## AMENDMENTS TO THE DRAWINGS

**REMARKS/ARGUMENTS****Election of Species**

Amend dated rec. v. 1.0  
Reply to Office Action dated Oct. 21, 2005  
Annotated Sheet Showing Changes

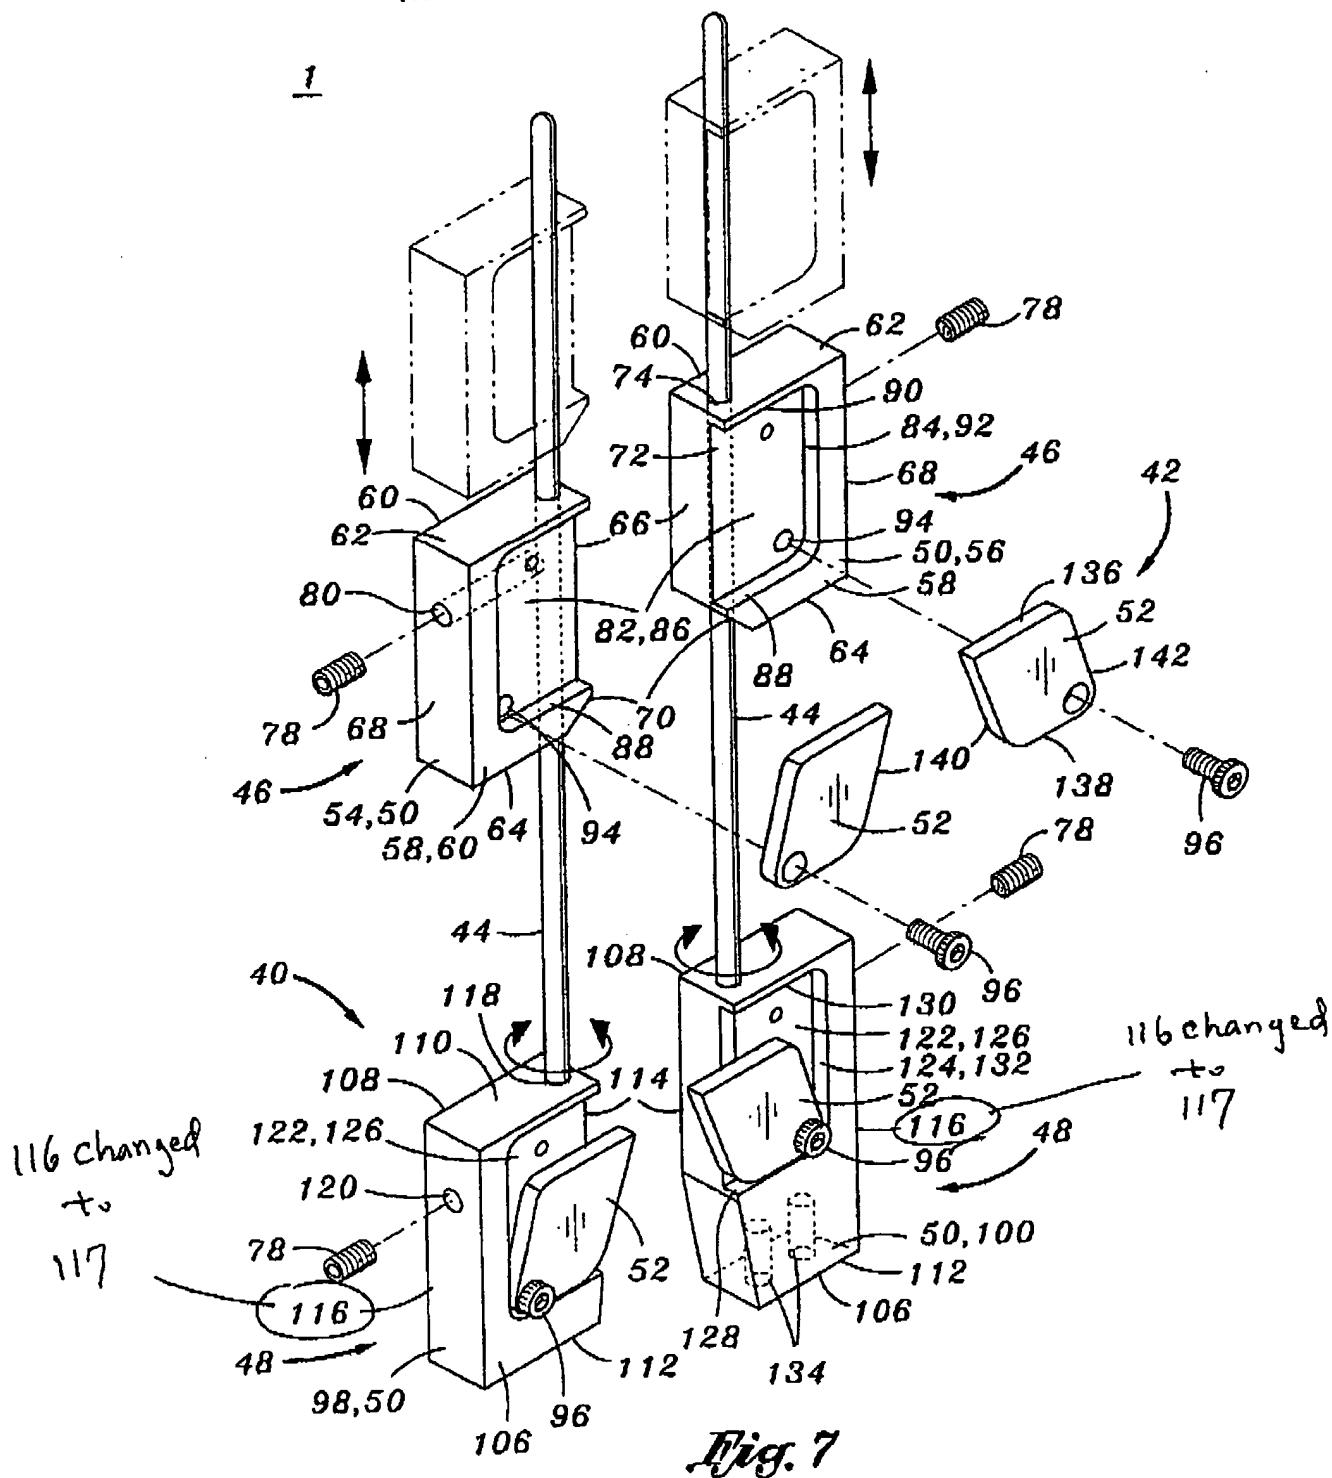
Figures 7 and 9 were objected to because reference character 116 was used to designate a second set screw receiving side and the second articulation bore. Figures 7 and 9 have been

amended. Reference character 116 now refers to second set articulation bore. Second set screw receiving side has been given the reference number 117.

Figures 7 and 9 are amended to change the reference numeral of second set screw receiving side from 116 to 117.
